## NOTICE TO CONTRACTORS

11-005

Proper Roof Bracing Update

(This Notice replaces Notice 08-005)

FIGURE R802.5.1  
BRACED RAFTER CONSTRUCTION

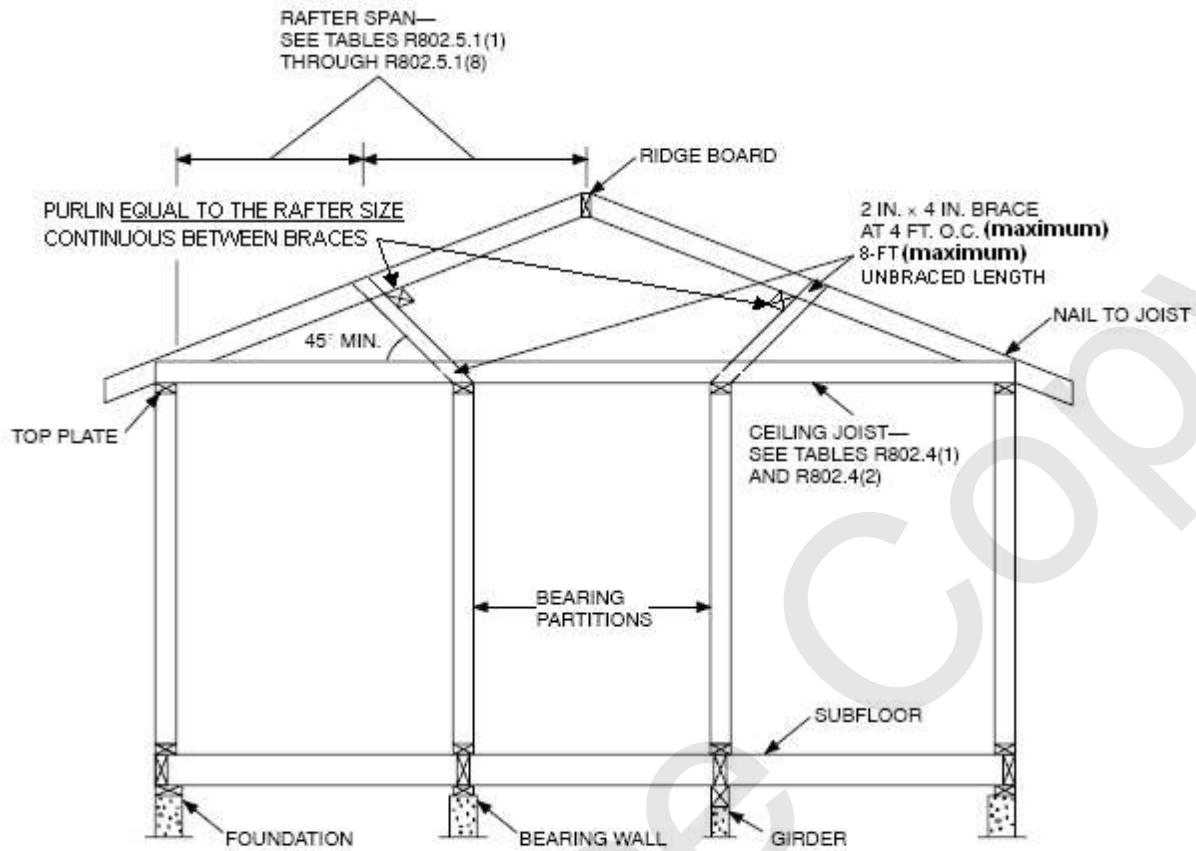
**Code Official's Administrative Ruling:** Page 2 illustrates how to properly brace rafters that exceed allowable spans based on species and grade of lumber. This illustration and Section R802.5.1 also require purlin bracing to be provided at 4'-0" maximum intervals and if bracing exceeds 8'-0" in length they shall also be braced. A new local amendment was added in the 2009 IRC adoption which permits purlin brace spacing to be increased to 6 feet on center when minimum 2 by 6 purlins are installed. Please remember that the code specifically requires that the minimum size of the purlin has to be equal to the rafter being supported. For example, a 2x6 purlin would not be allowed to support 2x8 rafters, even if it is supported every 6 feet. It is also important to note that purlin, ridge and hip braces may be installed to be supported by structural beams or columns as well as bearing walls. Braces landed on ceiling joist assemblies will not be acceptable. The new spacing allowance for the braces is effective immediately.

**Applicable Code Section(s):** **R802.5.1 Purlins.** Purlins are permitted to be installed to reduce the span of rafters as shown in Figure R802.5.1. Purlins shall be sized no less than the required size of the rafters that they support. Purlins shall be continuous and shall be supported by 2-inch by 4-inch (51 mm by 102 mm) braces installed to bearing walls at a slope not less than 45 degrees from the horizontal. The braces shall be spaced not more than 4 feet (1219 mm) on center for 2-inch by 4-inch (51 mm by 102 mm) or 6 feet (1829 mm) on center for 2-inch by 6-inch (51 mm by 152 mm) and the unbraced length of braces shall not exceed 8 feet (2438 mm).

**Note:** Where ceiling joints run perpendicular to the rafters, rafter ties shall be nailed to the rafter near the plate line and spaced not more than 4 feet on center.
